**PLANNING DEPARTMENT
CURRENT PLANNING STAFF ANALYSIS
SITE PLAN REVIEW**

CASE NO.: 2017-0017

Ship Creek Development, LLC is seeking final site plan approval of their condominium project, *Downtown Edge at the Rail*, which is located at the northwest corner of 2nd Avenue and Christensen Drive.

Subject: Case 2017-0017; Major Site Plan Review per AMC 21.15.030 (Old Code) for a Condominium Development (“Downtown Edge at the Rail”) in the Planned Community (PC) District.
(X-Ref: S12330)

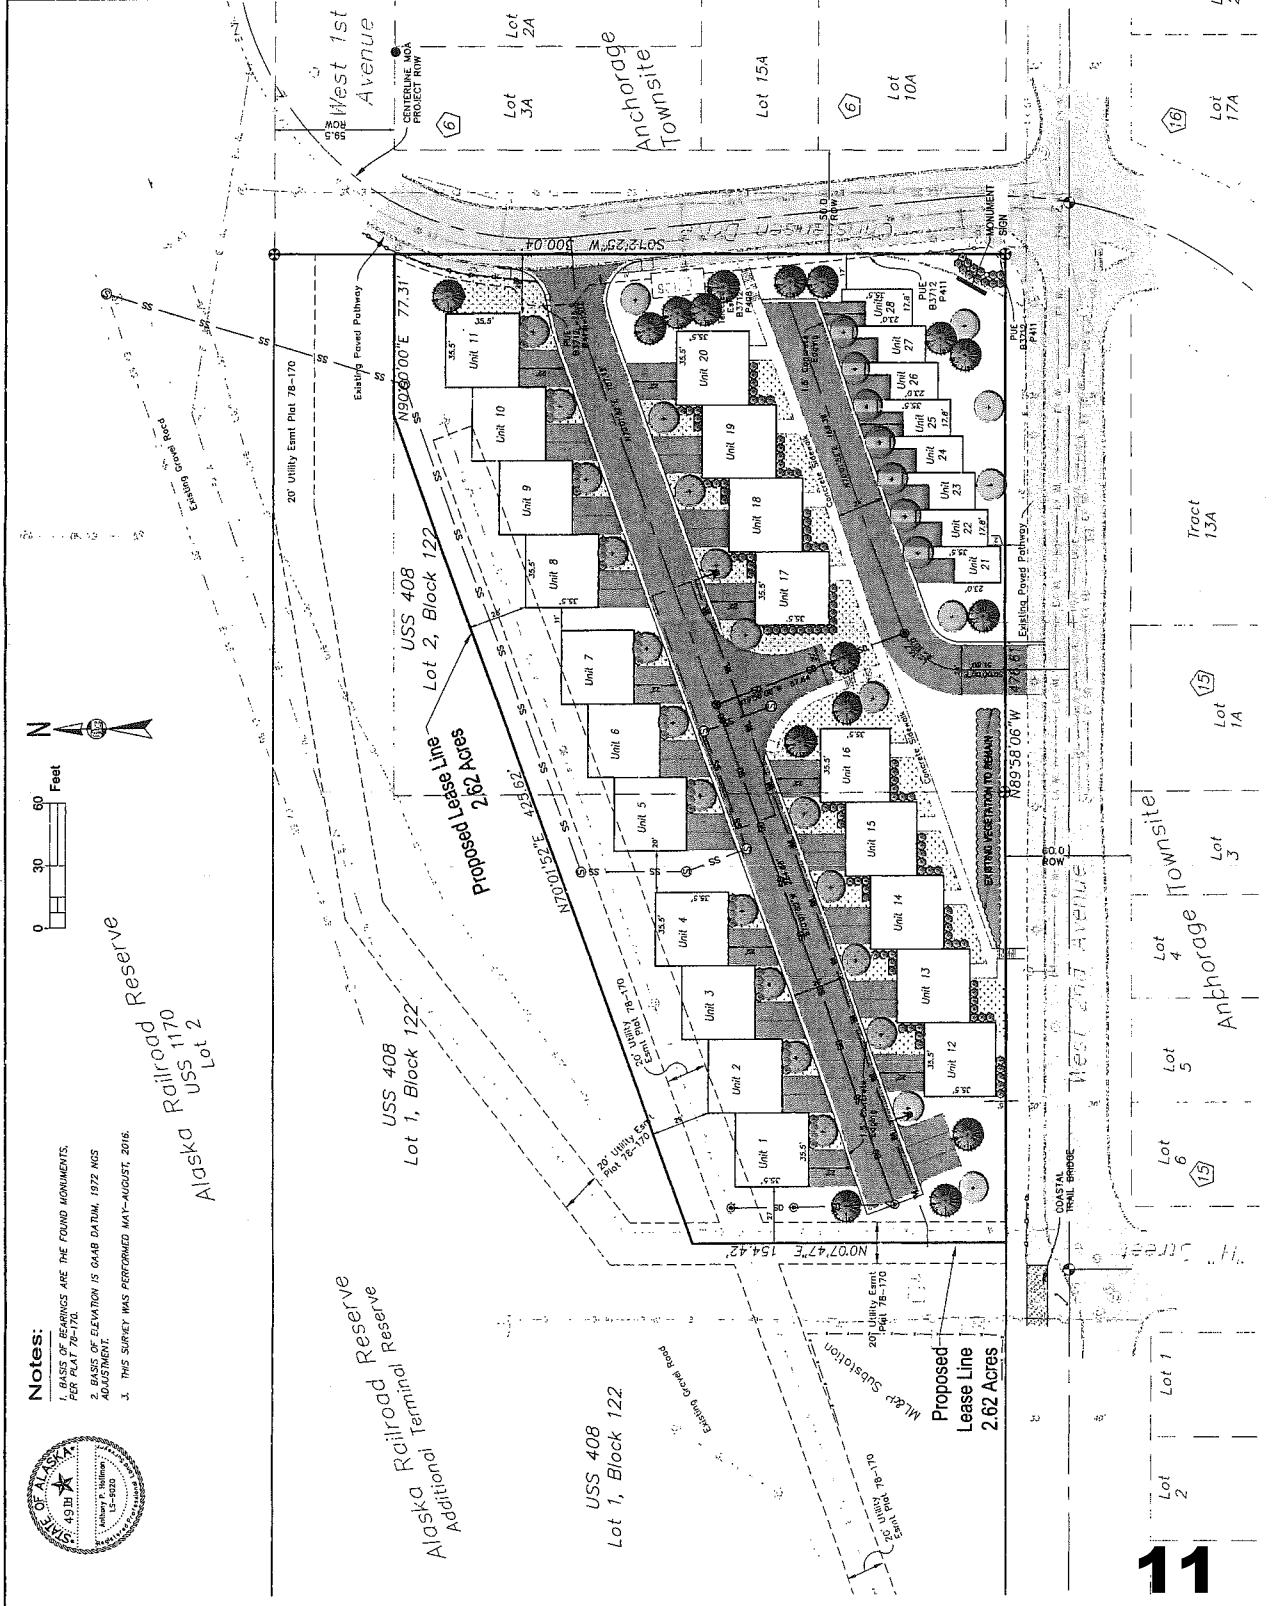
- a. Street off W. 2nd in excess of 150 ft. and provides no required emergency vehicle turn around. IFC D103.4
- b. Street off W. 2nd measures 24 ft. wide, requires 26 ft. wide if any structure is 30 ft. or higher. Unable to determine structure height from submittal, but photo rendition shows 3 stories which typically are 30+. IFC D105.3
- c. Street off Christensen requires additional emergency vehicle turn around at West end. IFC D103.4
- d. Access off Christensen shall have an interior exterior turning radius of 40ft/60ft. Show on plans. IFC D103.3
- e. All portions of the buildings shall be within 150 ft. access of an approved fire lane, North West building is greater than 150 ft from fire lane. IFC 503.1.1
- f. No grade shown or access to north side of units 1 thru 11. Show emergency vehicle access. IFC 503.1.1

- c. Street off Christensen requires additional emergency vehicle turn around at west end. IFC D103.4
 - d. Access off Christensen shall have an interior/exterior turning radius of 40ft/60ft. Show on plans. IFC D103.3

- f. No grade shown or access to north side of units 1 thru 11. Show emergency vehicle access. IFC 503.1.1
4. Resolve with Addressing the following comments:
